23rd October 2015

Response to Agency Comments on Civil Drawings and Report – The Next Generation, Energy from Waste Plant, Eastern Creek

SSD 6236 – Energy from Waste Facility Memo from Blacktown City Council

SEPP 59 CP18 Review – Post Development Rafts Catchments

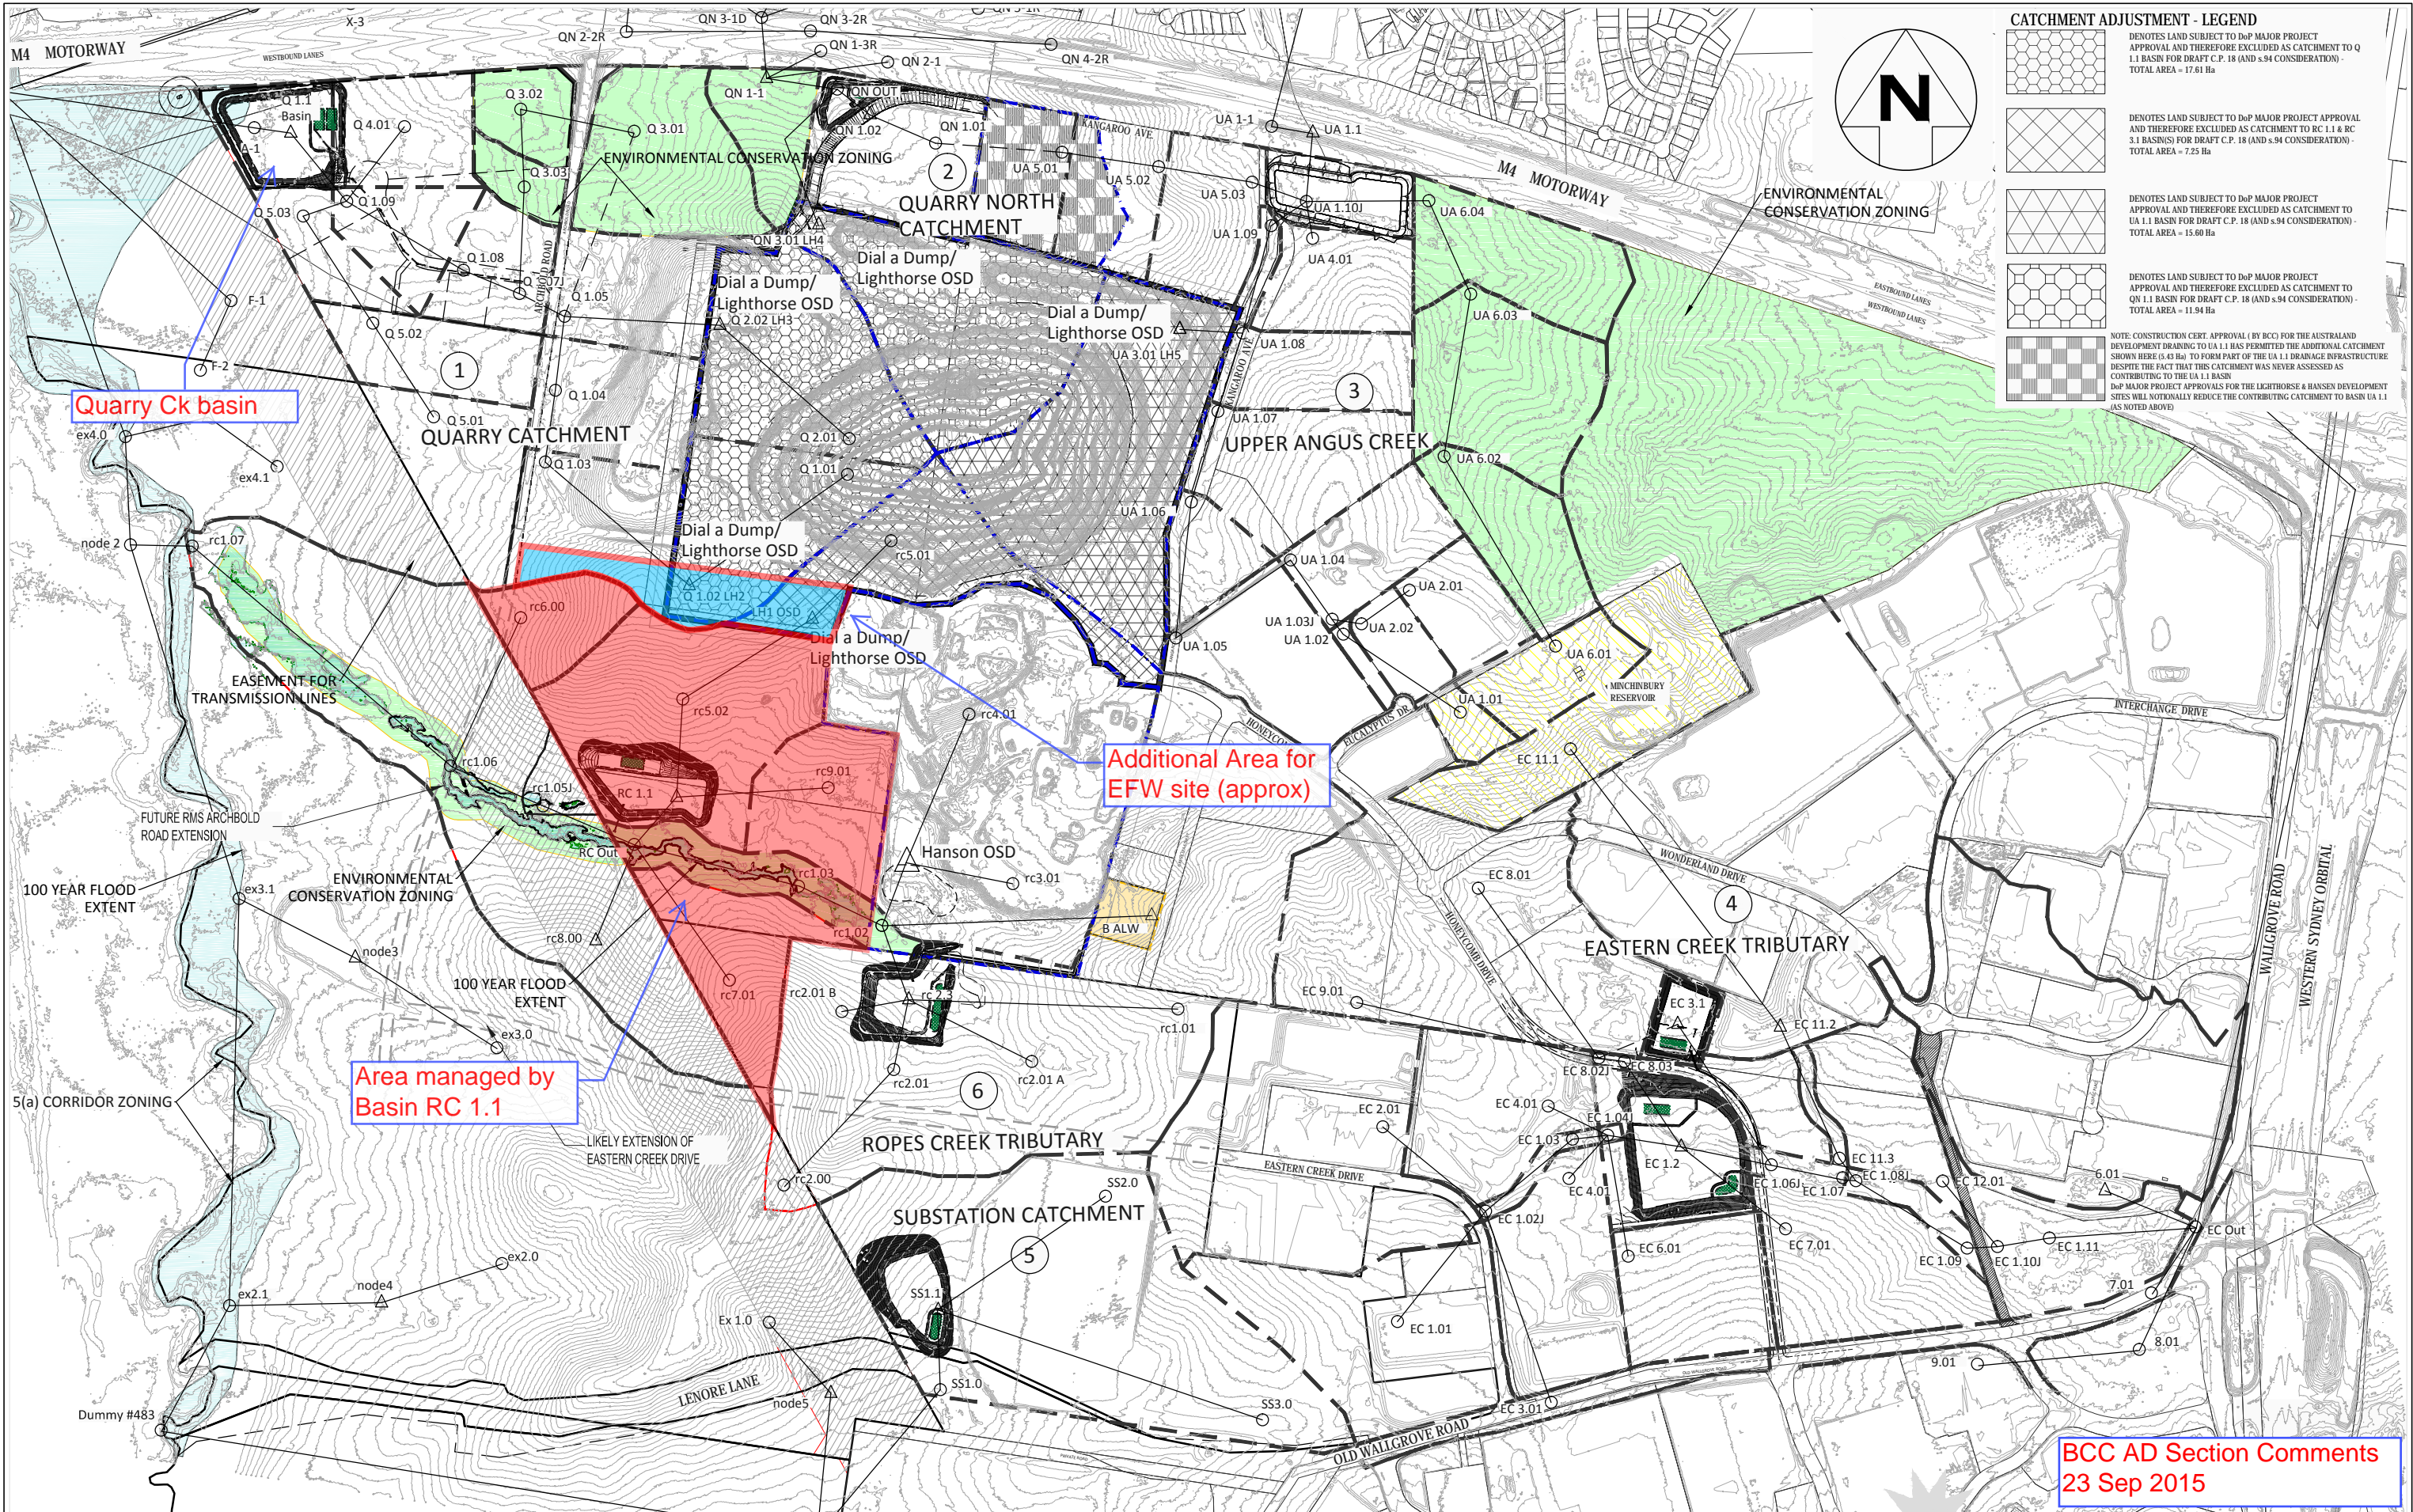
Under the Precinct Plan and the draft Section 94 Contributions Plan (CP 18) for the area, it is planned to provide a precinct stormwater control basin at this location (Basin RC 1.1) to manage the peak flows off the catchment and to treat the flows of the roads only. This basin has a capacity of 14,500 m³ and a PSD of 1.10 m³/s in the 100 Year ARI and 0.32 m³/s in the 2 Year ARI. Attached is the catchment plan showing the area for which this basin manages the stormwater.

Quarry Ck basin

Additional Area for EFW site (approx)

Area managed by Basin RC 1.1

AT&L Response: As previously mentioned the detention basin and outlet flow rates have been designed to comply with the SEPP59 Eastern Creek Precinct Plan. The required basin capacity and PSD within the CP18 plan will be adopted in the civil design of the OSD basin prior to Construction Certificate application.
